# NORTH INDUSTRIAL AREA STRUCTURE PLAN

**BYLAW NO. 923-22**

Consolidated to Bylaw 937-23, August 2023

## BYLAW NO. 937-23

# RME UTILITY SERVICING

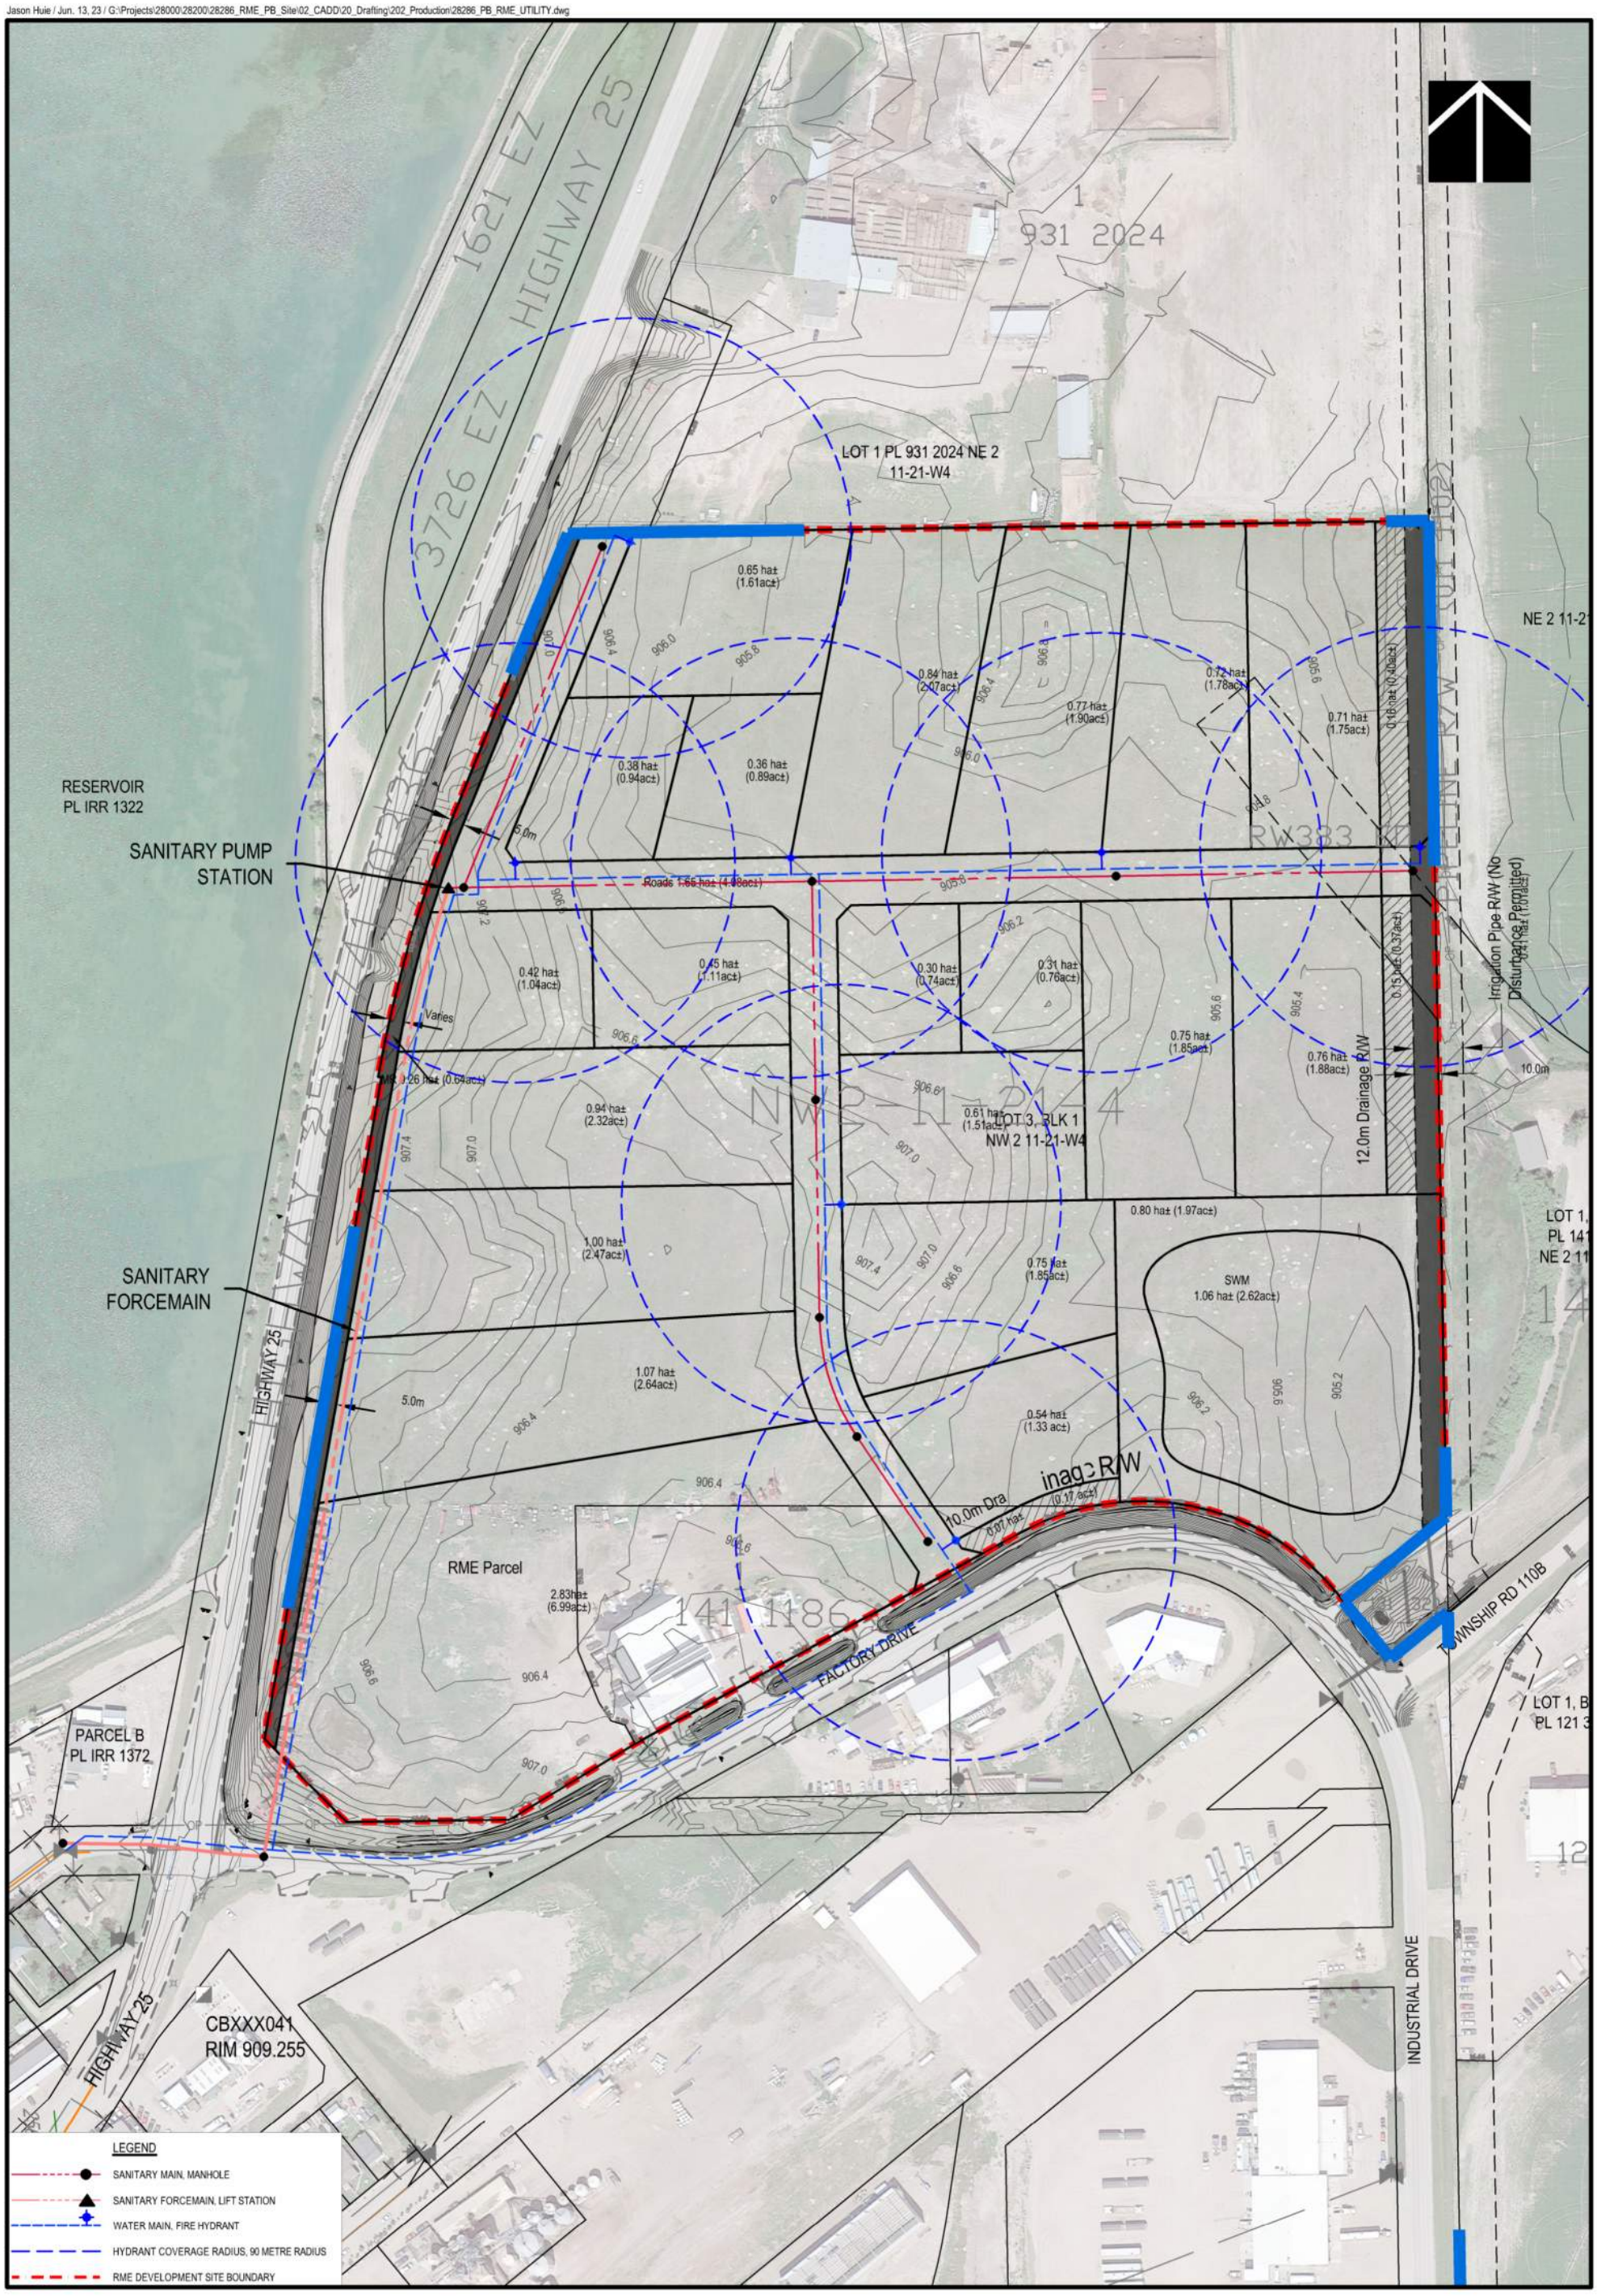
We have revised the servicing plan and it is updated to reflect the revised lot layout, please see the attached exhibit. Although the servicing layout within the proposed subdivision is modified from the previous lot layout provided in 2020, the connection points and alignments outside the development area for water, sanitary and storm remain the same.
